10 HNC - 47 Eagle Crest Court, Lillington, NC 27546

# PLAN 1 The Clayton - RH

10-16-24 - Redlines - JJ

THE CLAYTON - RH  
---  
Cover Sheet 'Craftsman'

**SLAB FOUNDATION PLAN 'CRAFTSMAN'**  
SCALE: 1/8"=1'-0" ON 11x17, 1/4"=1'-0" ON 22x34

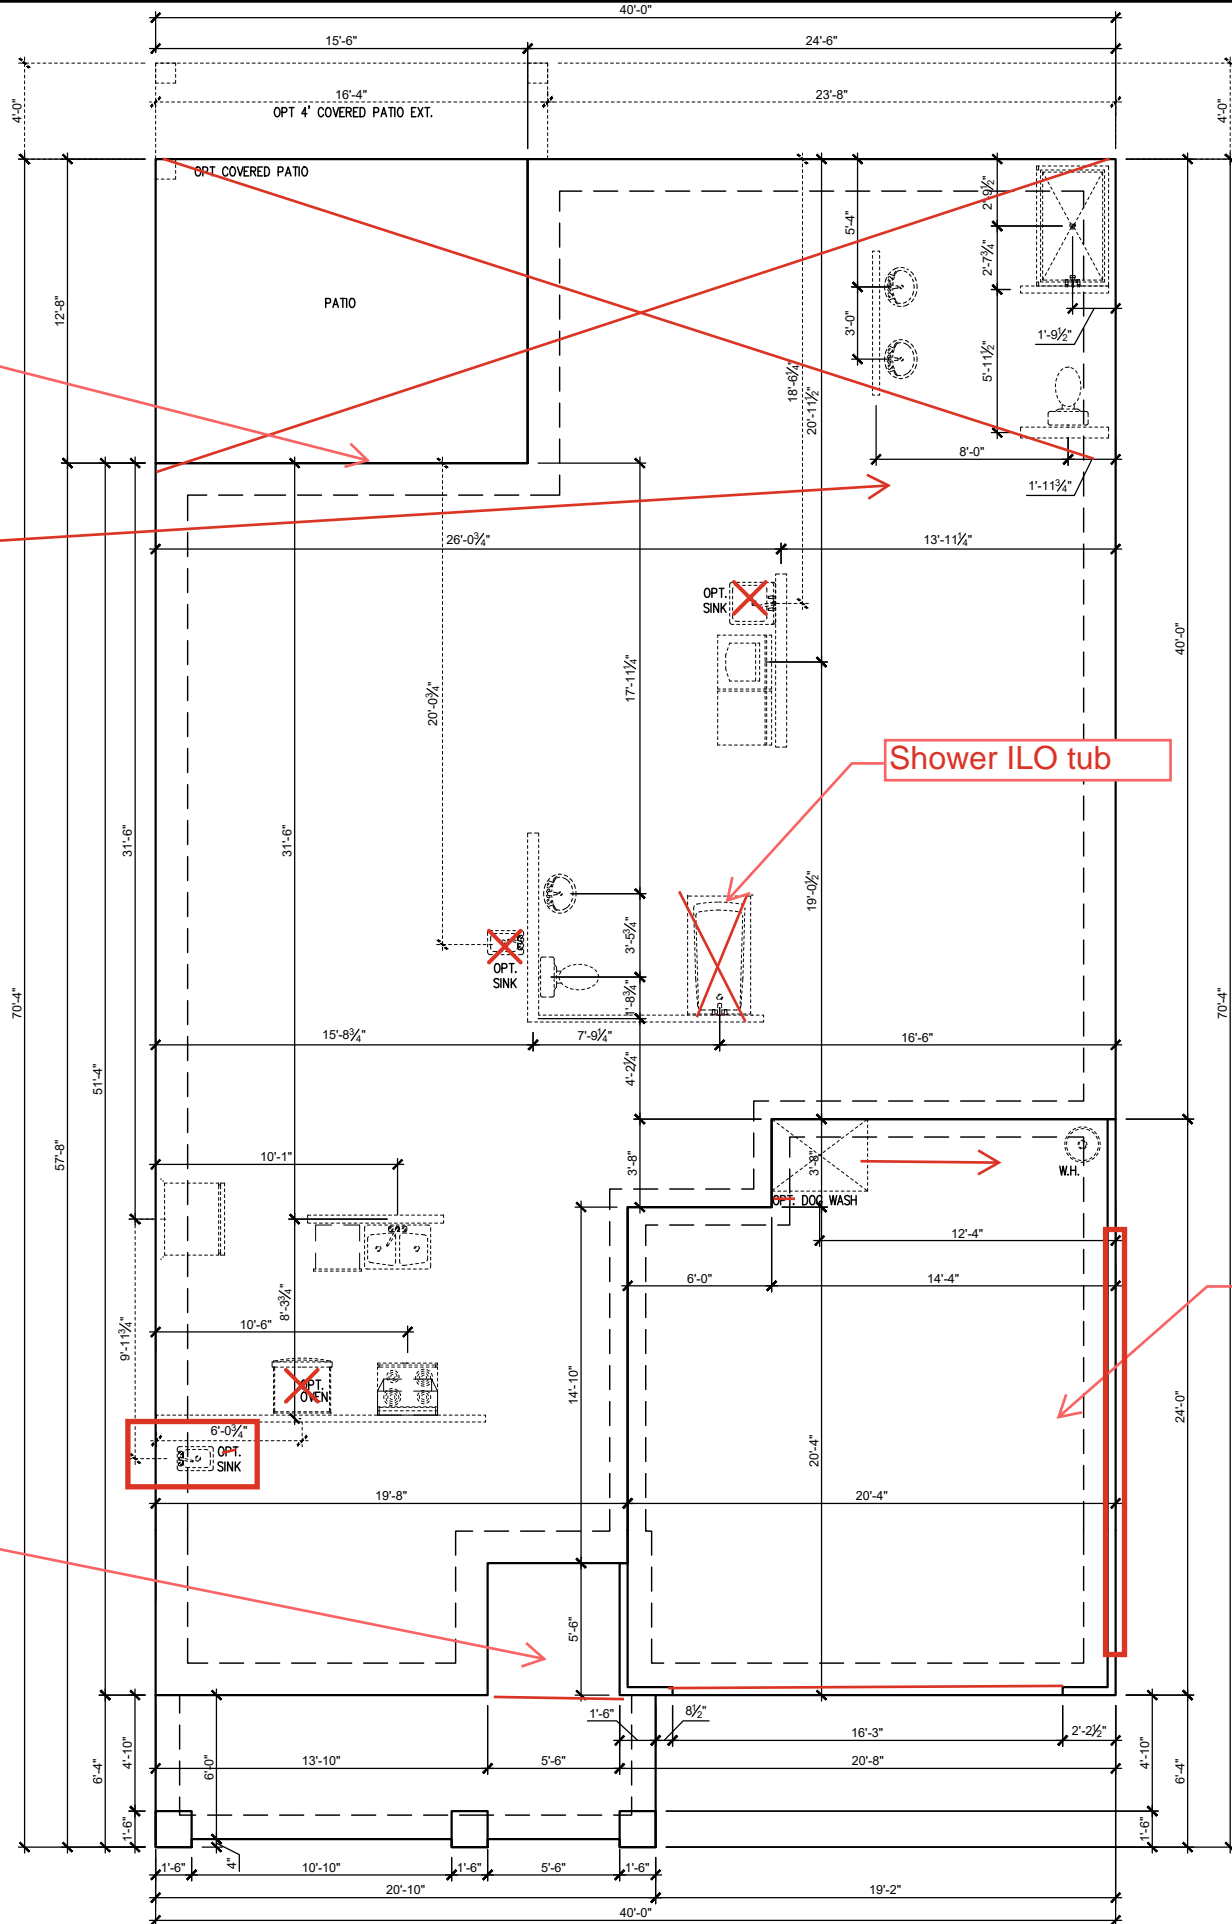
1.1.1c - Family room fireplace @ covered porch

Shower ILO tub

1.1.1c - side load garage

1.1.1c Smart Door Delivery

**FIRST FLOOR PLAN 'CRAFTSMAN'**  
SCALE: 1/8"=1'-0" ON 11x17, 1/4"=1'-0" ON 22x34

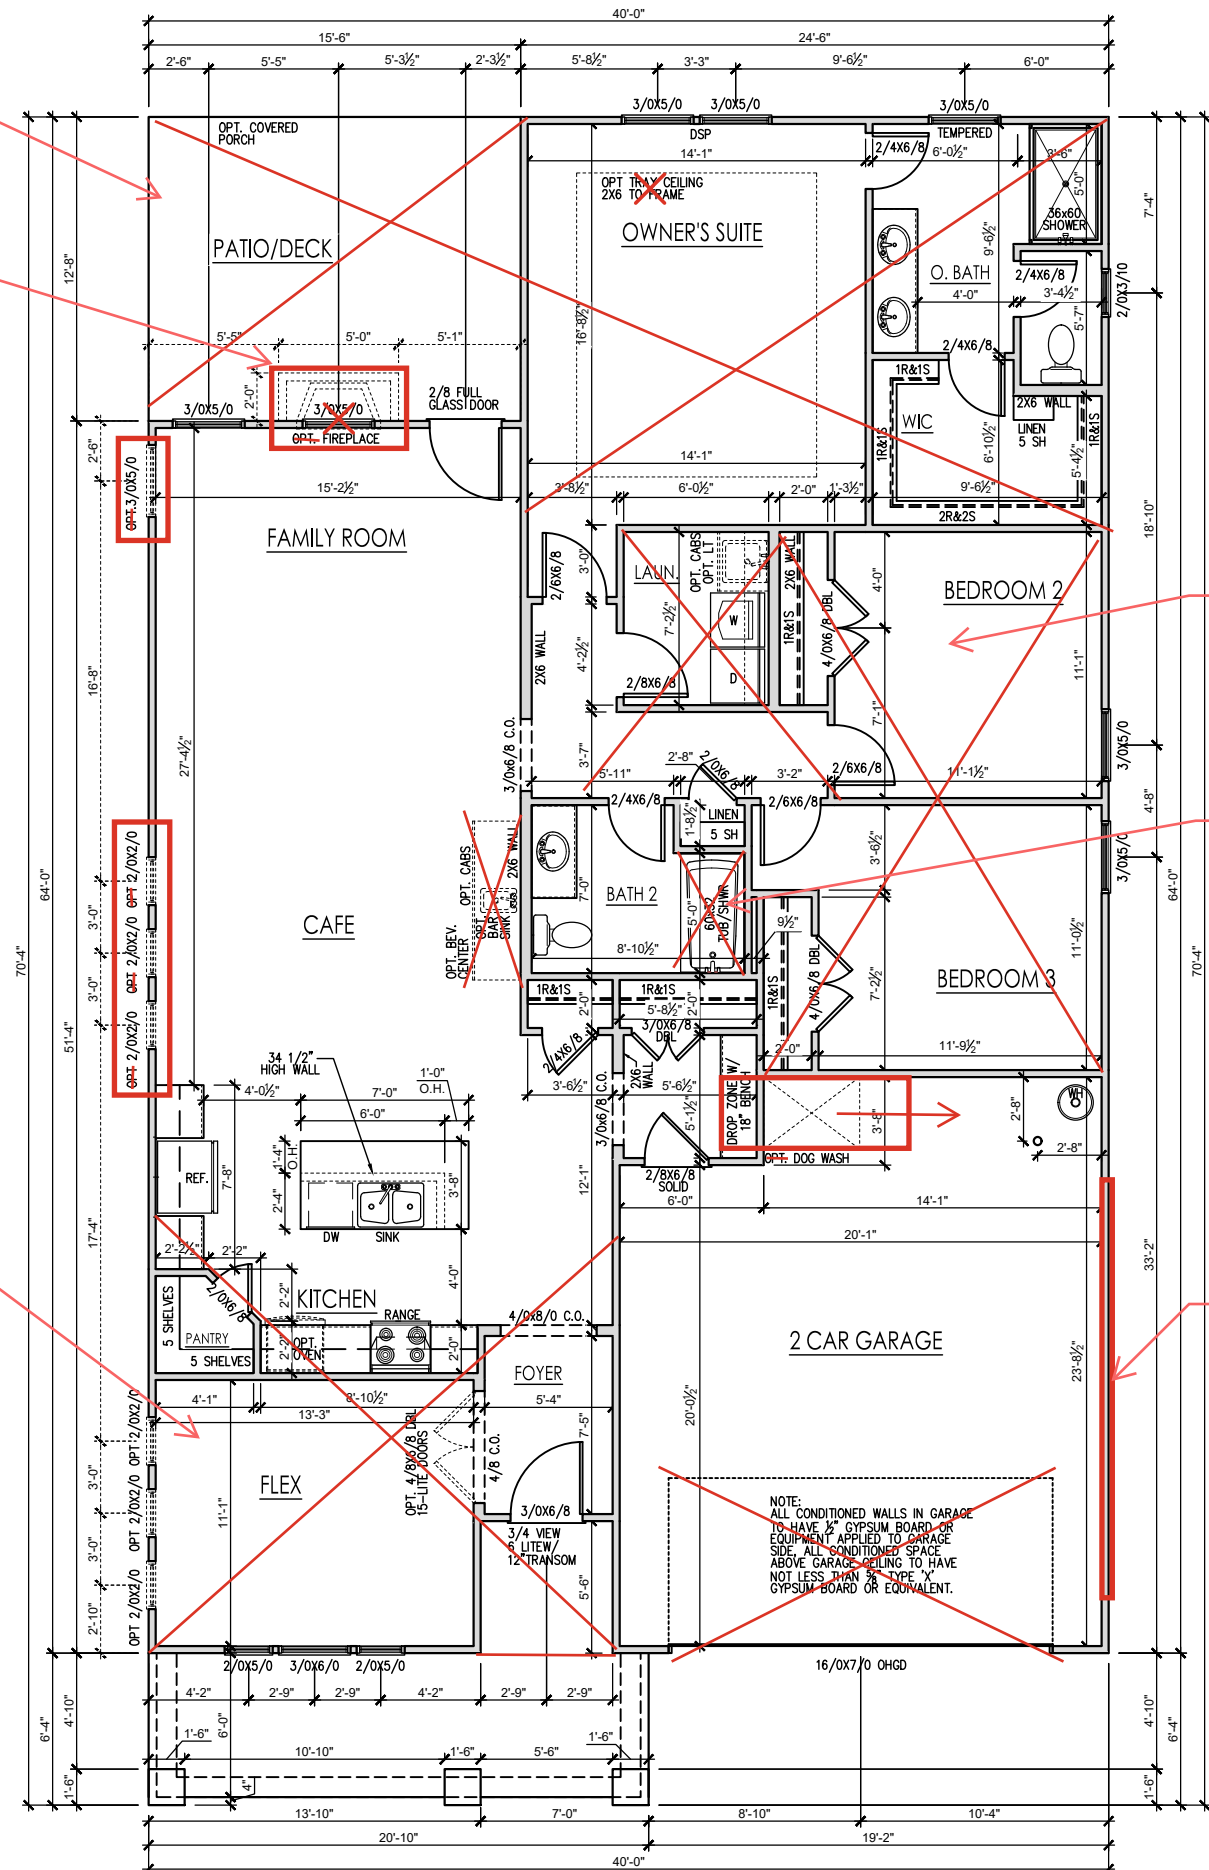
2.4c - covered porch

2.1.1c - family room fireplace @ covered porch

2.1.2c - owner's bath, bedroom 2, laundry and stairs to 2nd fl.

Shower ILO Tub Shower: Tile surround w/ fiberglass pan

2.1.1c - Smart Door Delivery, Pantry, Messy Kitchen, Pocket Office and Kitchen

2.1.1c Side Load

Front & Rear Elevations (Slab) 'Craftsman'

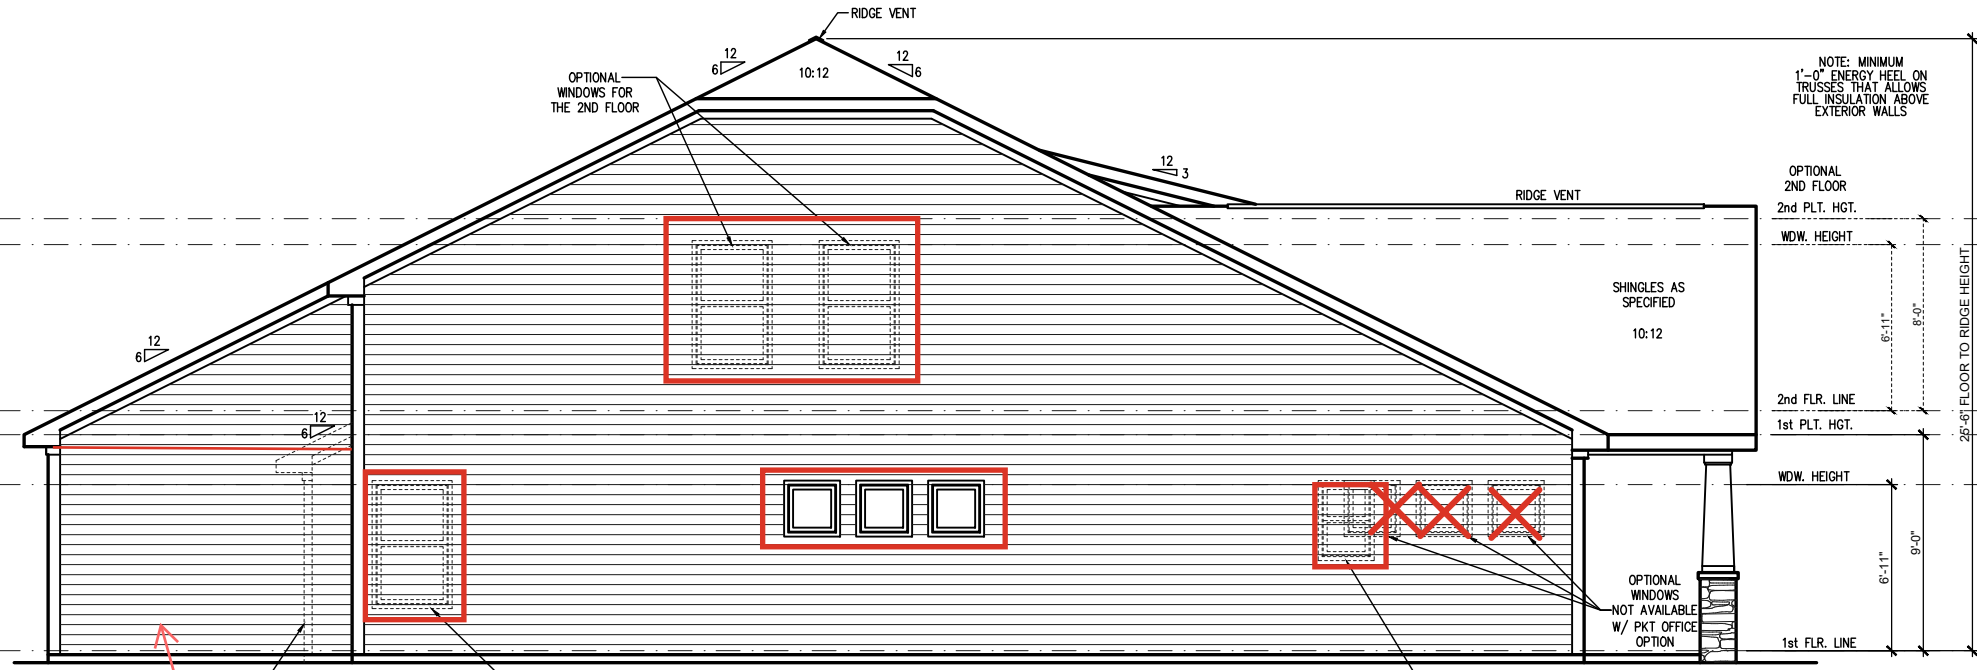
3.3c - side load garage

**RIGHT SIDE ELEVATION 'CRAFTSMAN' (SLAB)**  
SCALE: 1/8"=1'-0" ON 11x17, 1/4"=1'-0" ON 22x34

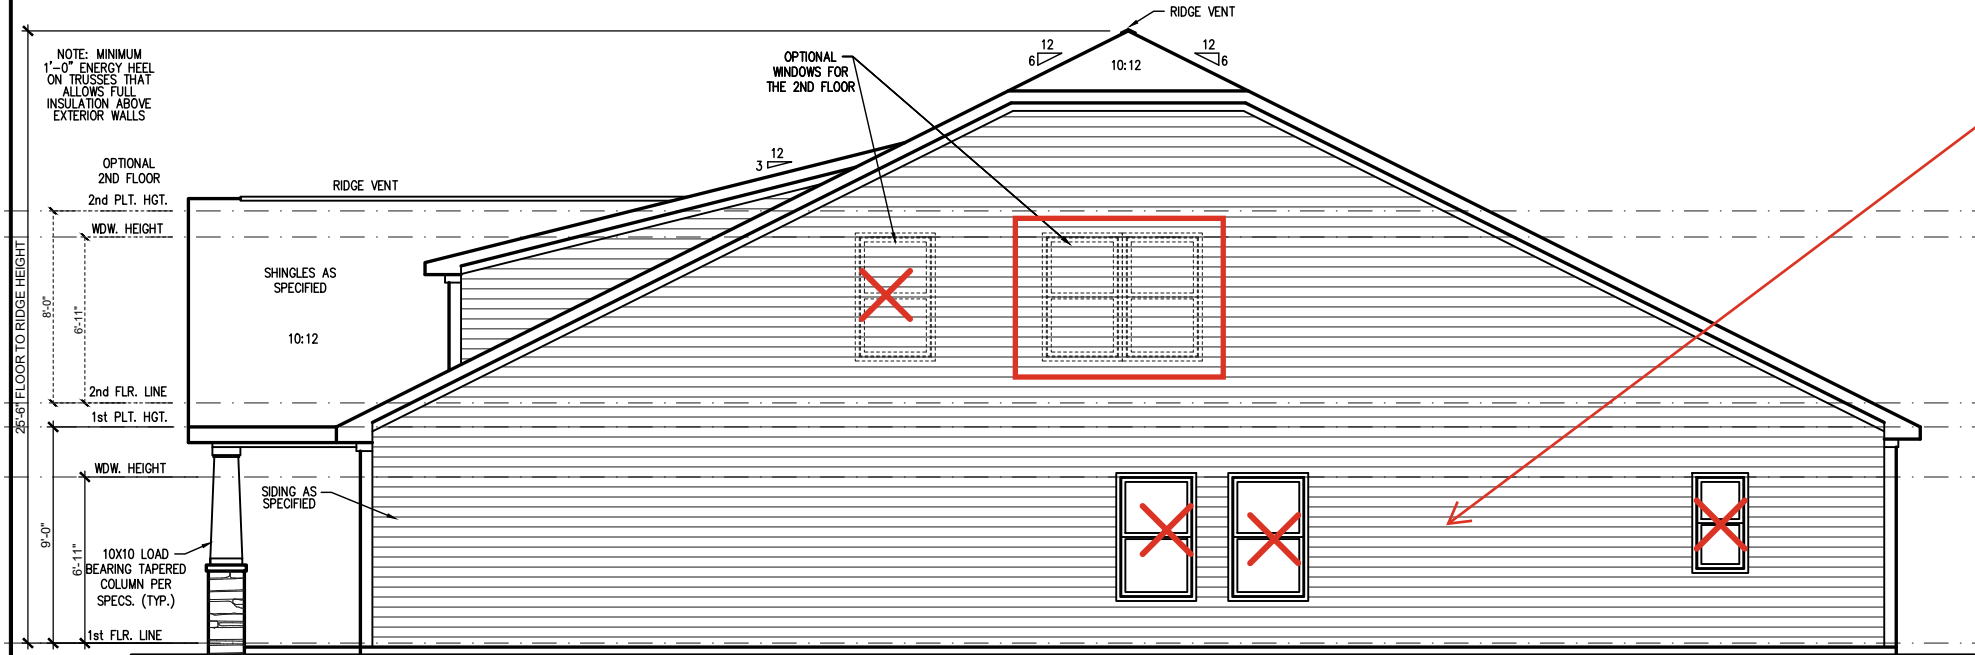
2.4c - covered porch

CRAFTSMAN ROOF PLAN  
SCALE: 1/4" = 1'-0" ON 22x34, 1/8" = 1'-0" ON 11x17

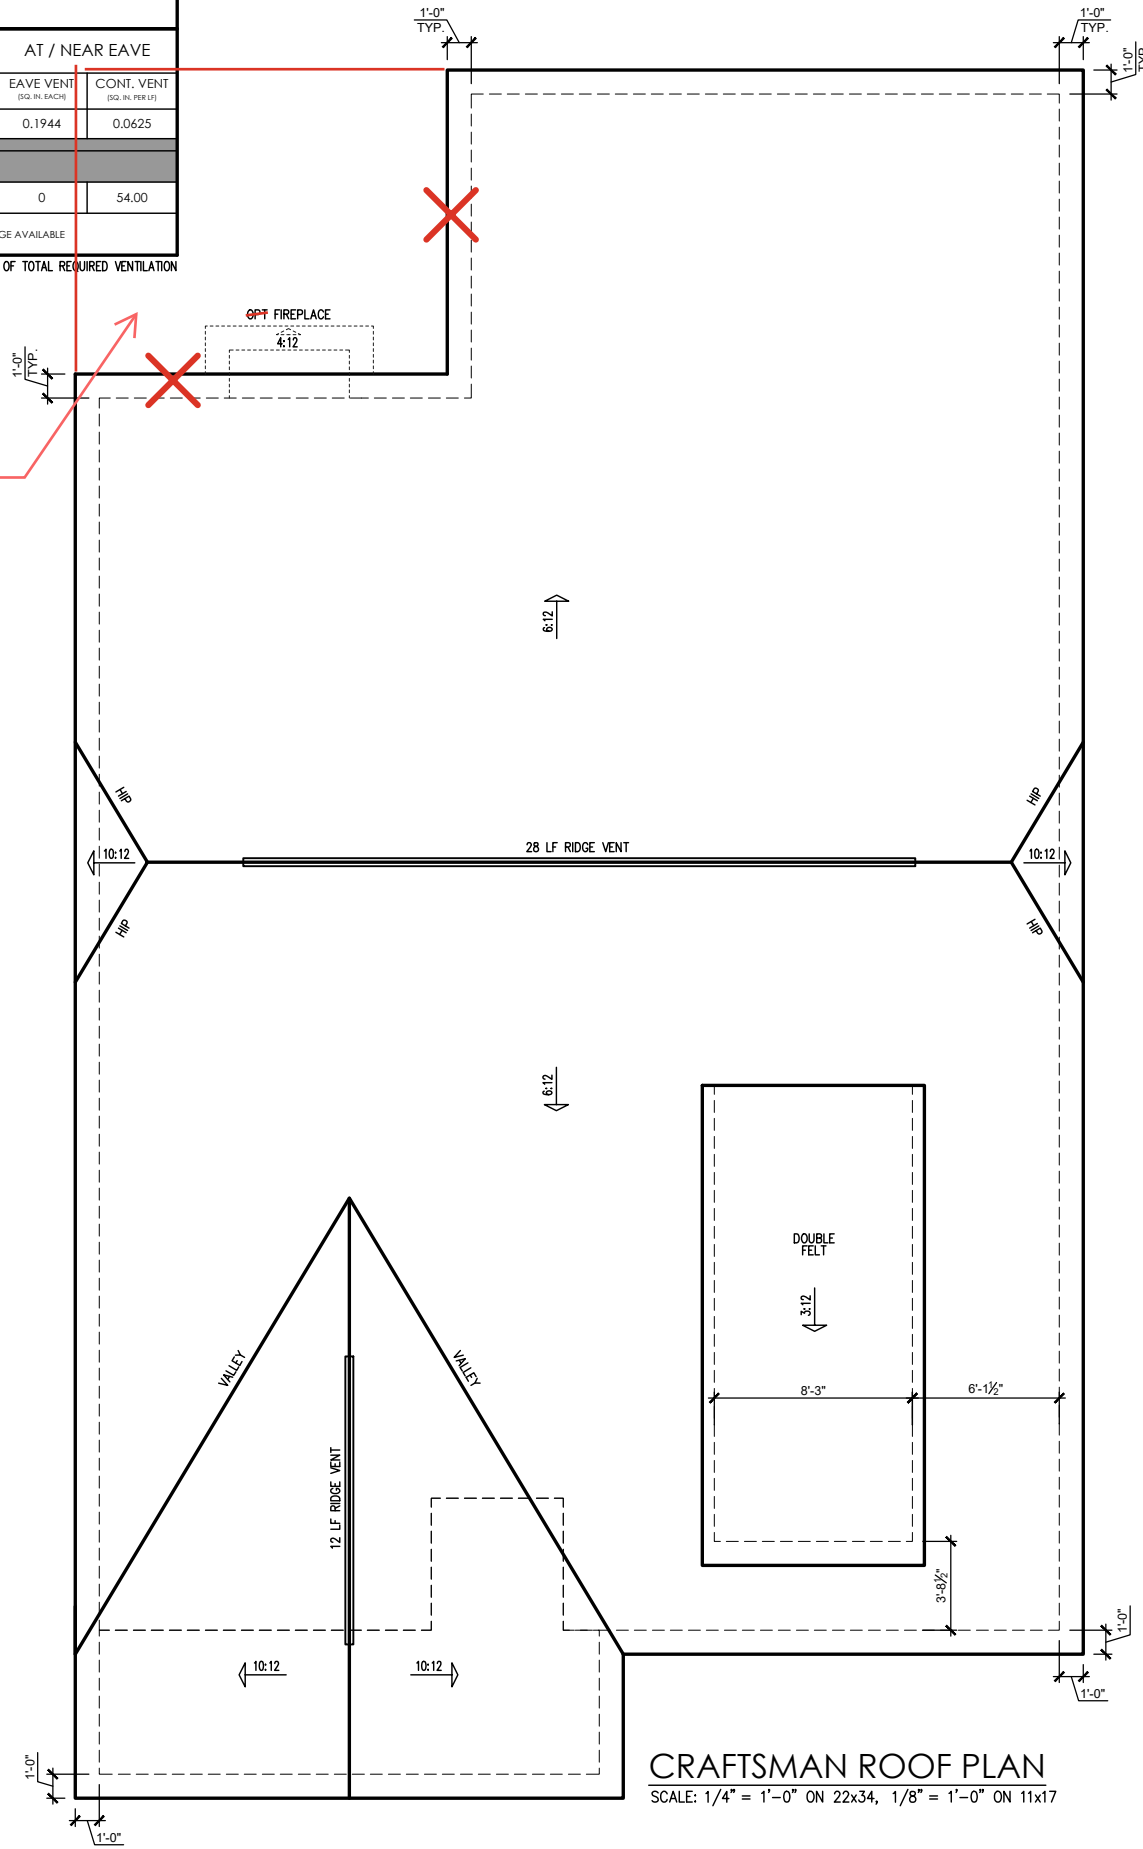
2.4c - Covered porch roof

**WITH SECOND FLOOR  
FIRST FLOOR PLAN 'CRAFTSMAN'**

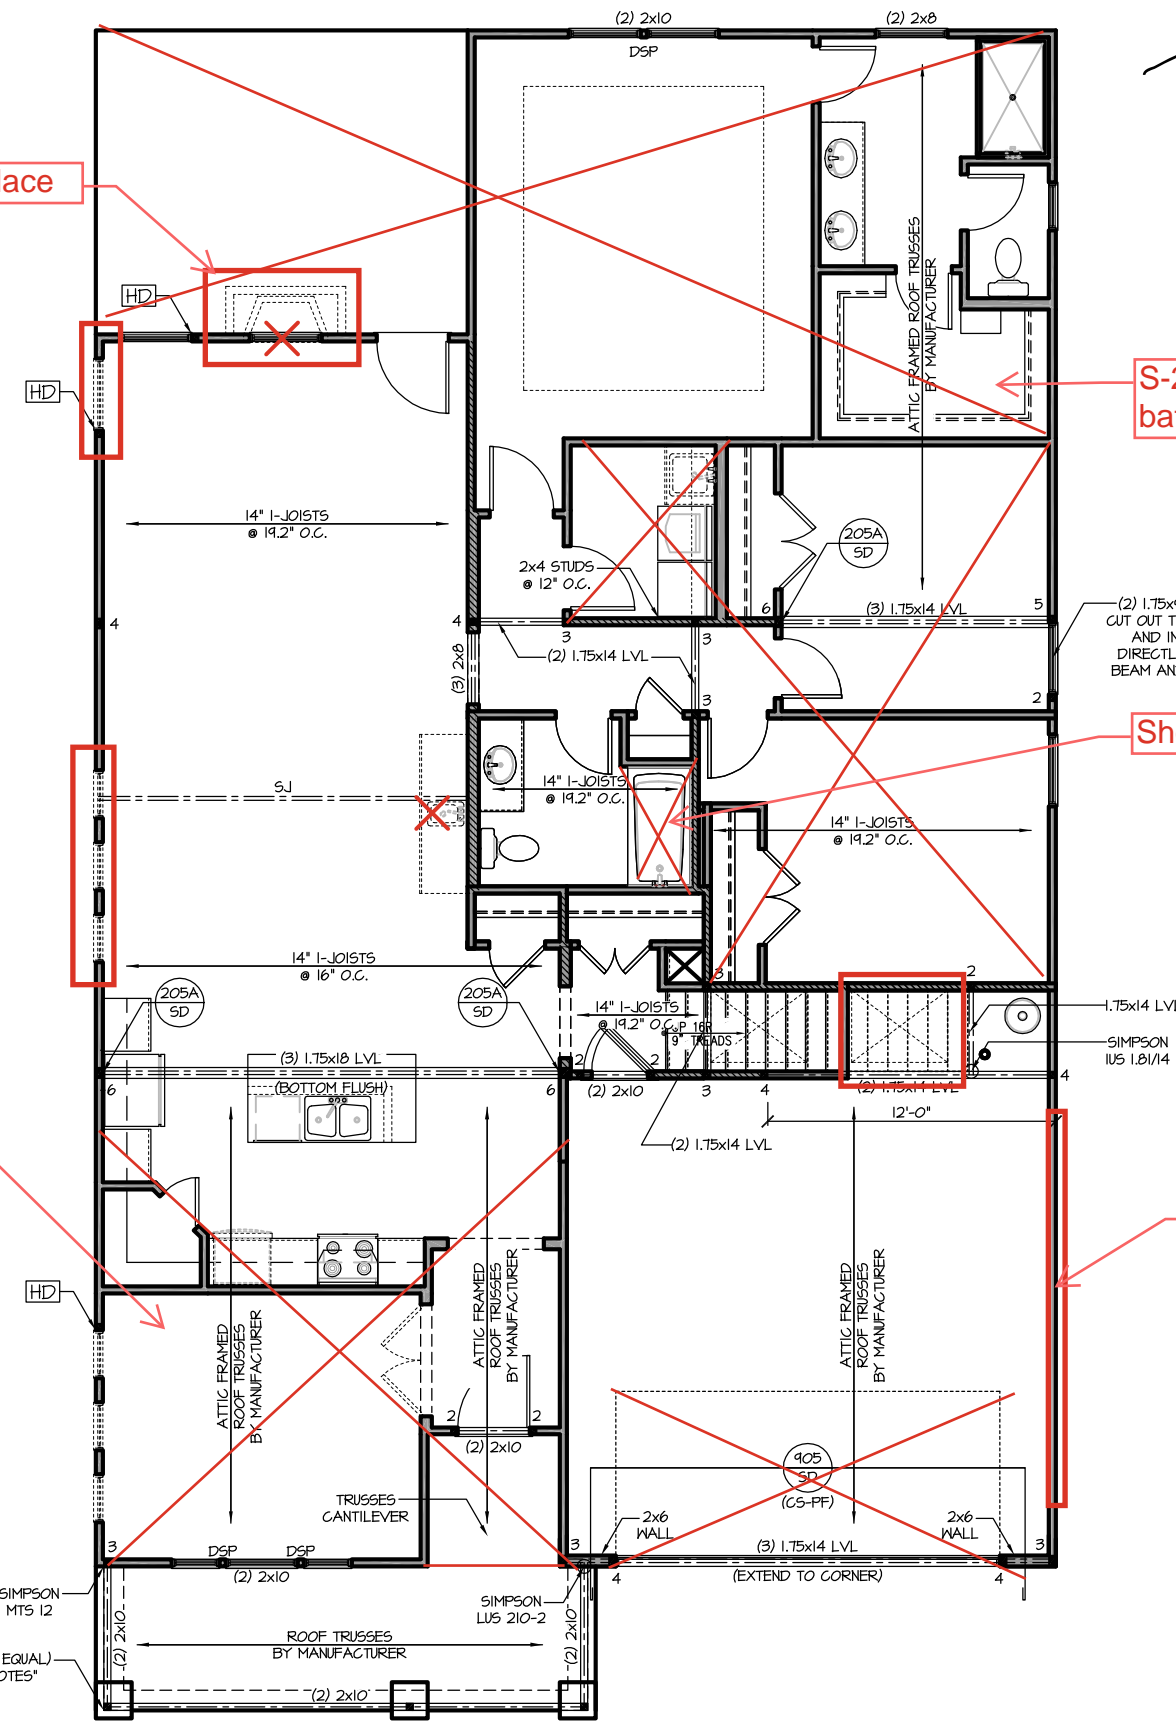
S-2.1.1 - fireplace

S-2.1.2 - Owner's bath & bed 2
